RE: Inspection of Lake Conestee Dam D-2876, Greenville County

Preliminary Inspection Report for South Carolina Regulated Dams and Impoundment Structures Regulations R.72-1 through R.72-9

3. Seepage and ochre present on the right face of the dam

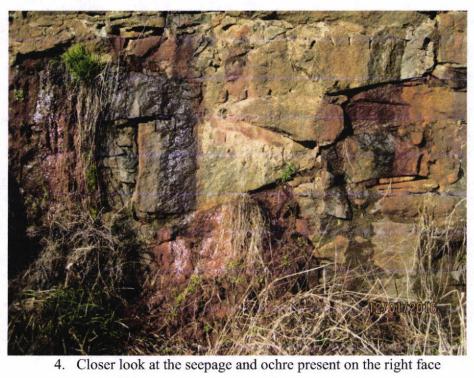
- Multiple areas of seepage were observed throughout the downstream face and toe of the dam on both the left and right side. According to laboratory results provided by the Conestee Foundation, the test samples of the seeps and ochre contain high levels of hazardous constituents. The volume of flow as well as the presence of hazardous constituents may be detrimental to the mortar joints and fissures currently present and may accelerate the deterioration of these joints. As part of the detailed inspection, these areas must be evaluated to determine whether it is affecting the safety of the dam and a plan developed to address these concerns.

6. Dam crest

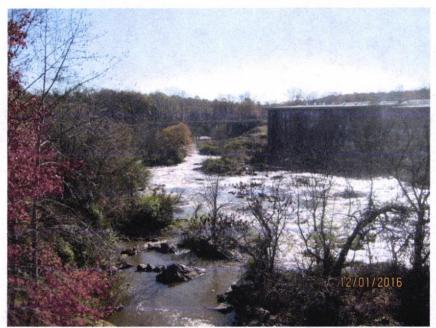
- Deterioration of mortar between joints and along the crest of the dam was observed. Continue to monitor these areas to ensure that the deterioration does not worsen to a point that would affect the structural stability of the dam. As part of the detailed inspection, these areas must be evaluated.
